Re: Letter of Intent . . . EA-17-075 ARACO ENTERPRISES, LLC
Drive (APN 65244-00-085)

SITE DEVELOPMENT PLAN
EL PASO COUNTY, COLORADO

FILE NO. EA-17-075

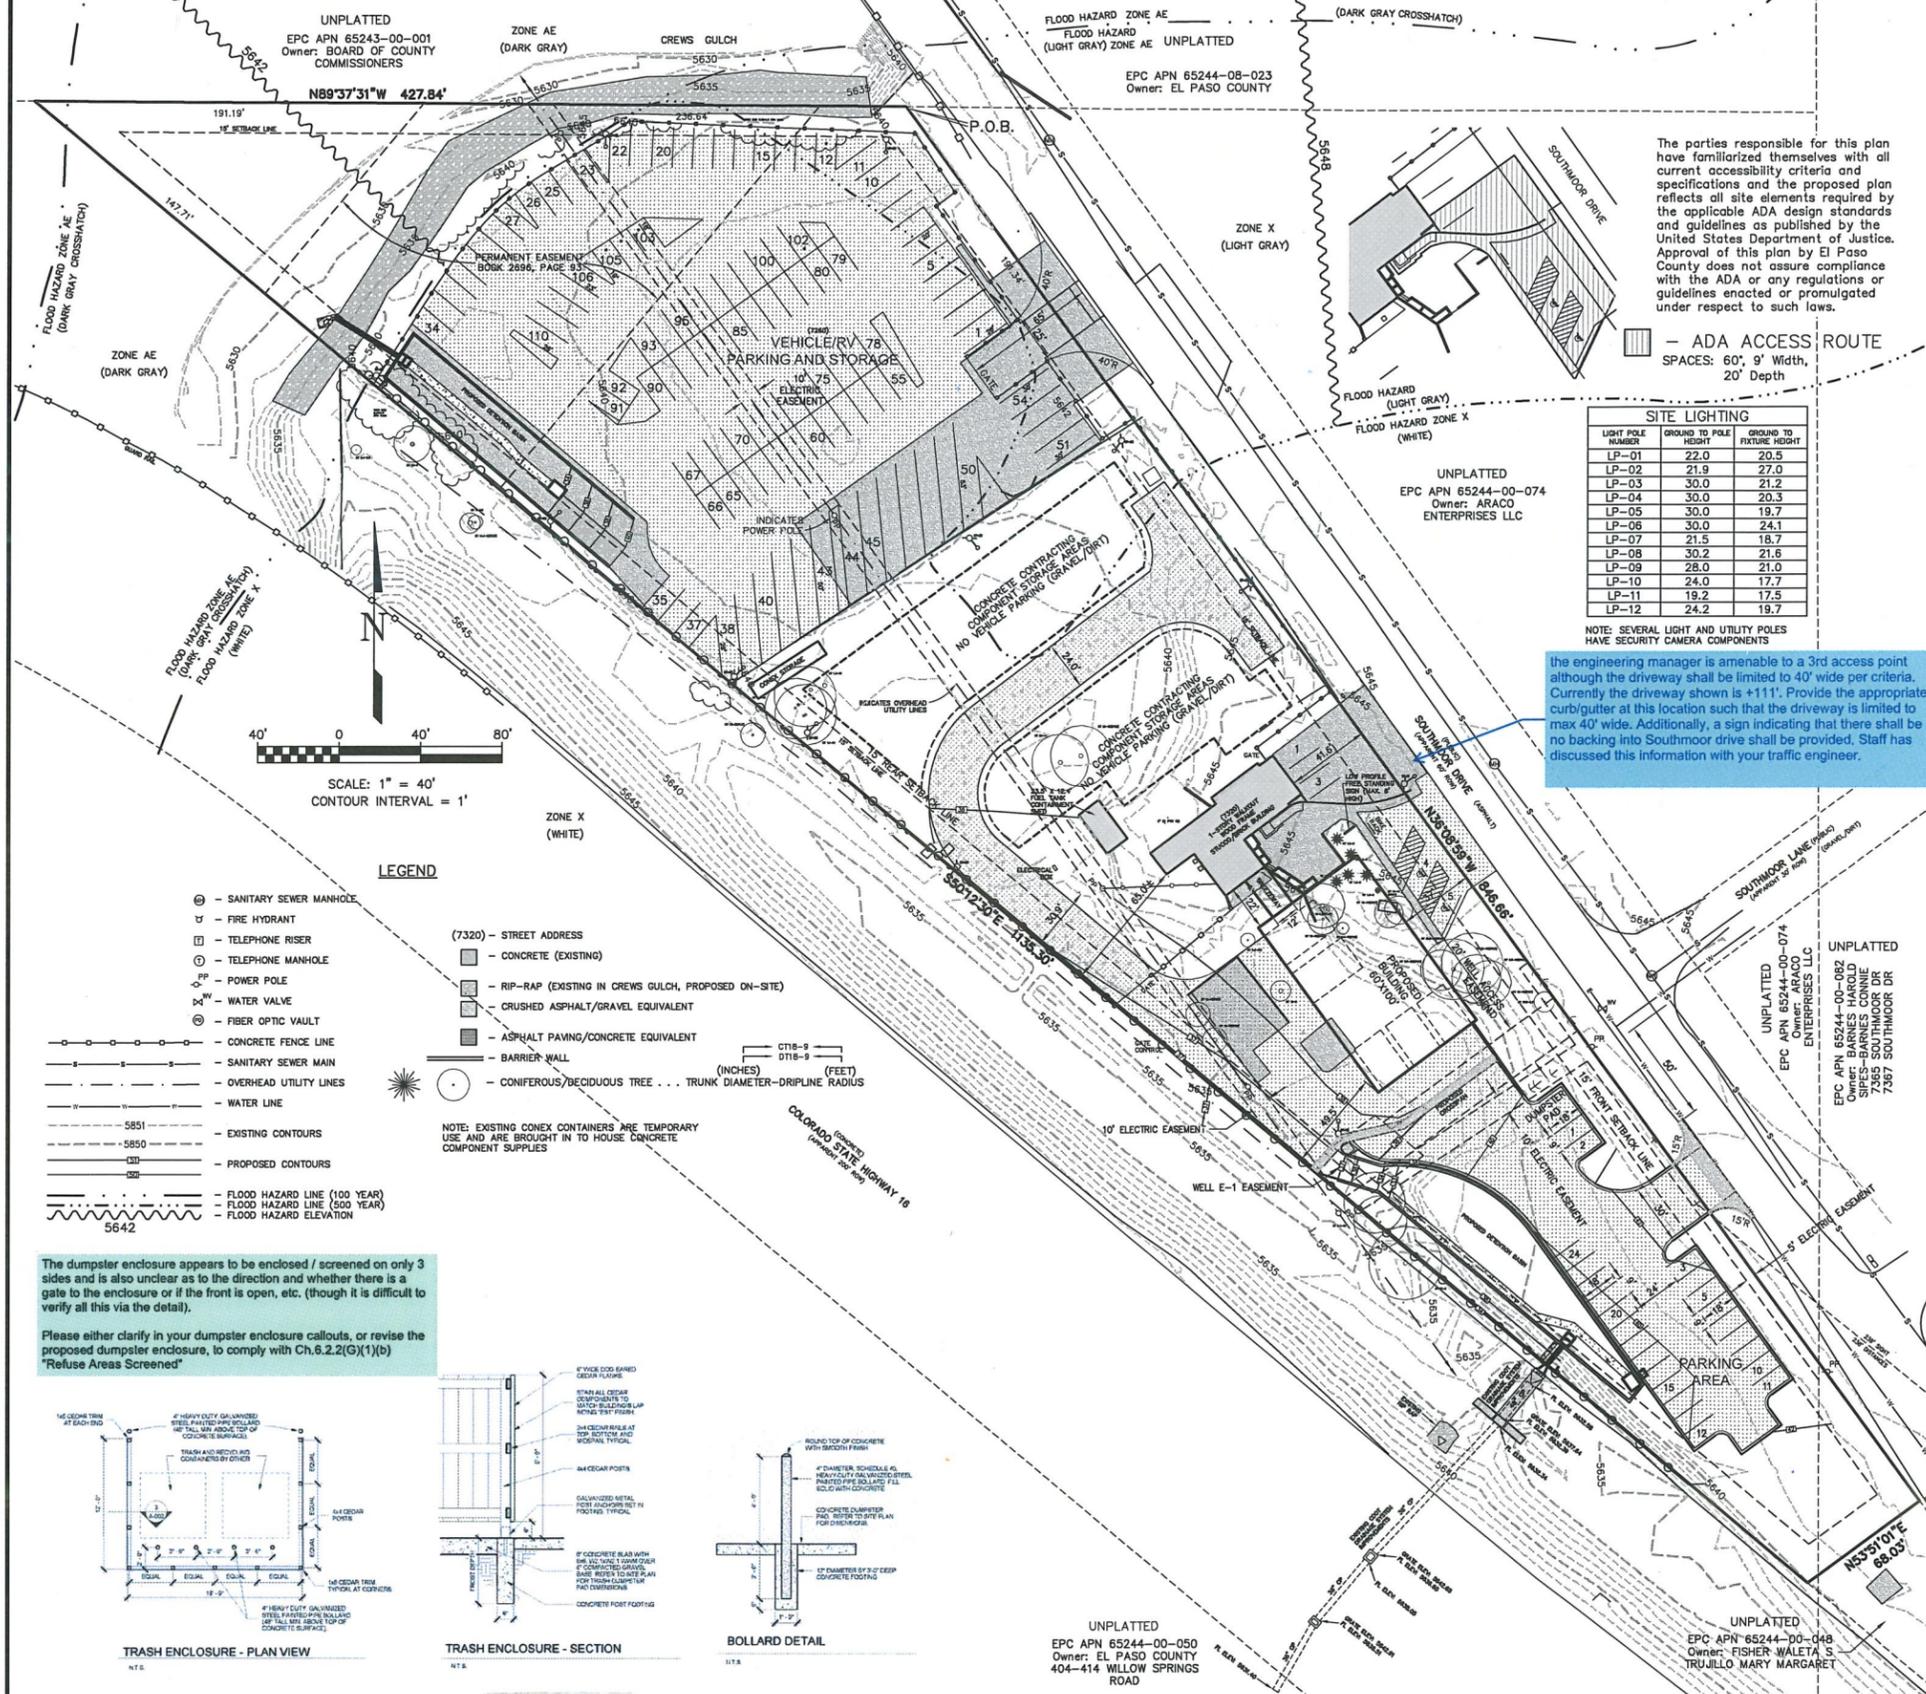
The TIS response attached to the report indicated that the vehicle repair garage has been removed from the letter of intent. For clarity, please add a statement that the vehicle repair garage is for servicing the company's own vehicles. If that is not the case then coordinate with the traffic engineer so that the vehicle repair garage is reflected in their traffic study.

CLARIFIED AS SERVICING THE
COMPANY'S OWN VEHICLES - DVH

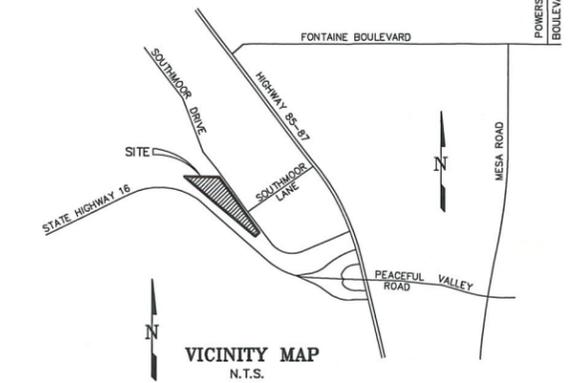
the engineering manager is amenable to a 3rd access point although the driveway shall be limited to 40' wide per criteria. Currently the driveway shown is +111'. Provide the appropriate curb/gutter at this location such that the driveway is limited to max 40' wide. Additionally, a sign indicating that there shall be no backing into Southmoor drive shall be provided. Staff has discussed this information with your traffic engineer.

CREATED 40' WIDE
DRIVE PAV FOR
DUMPER/EMPLOYEE USE
OF TRAFFIC (3) PARKING
SPACES w/ SIGNAGE
INDICATING "NO BACKING
INTO SOUTHOOR DRIVE" - DVH
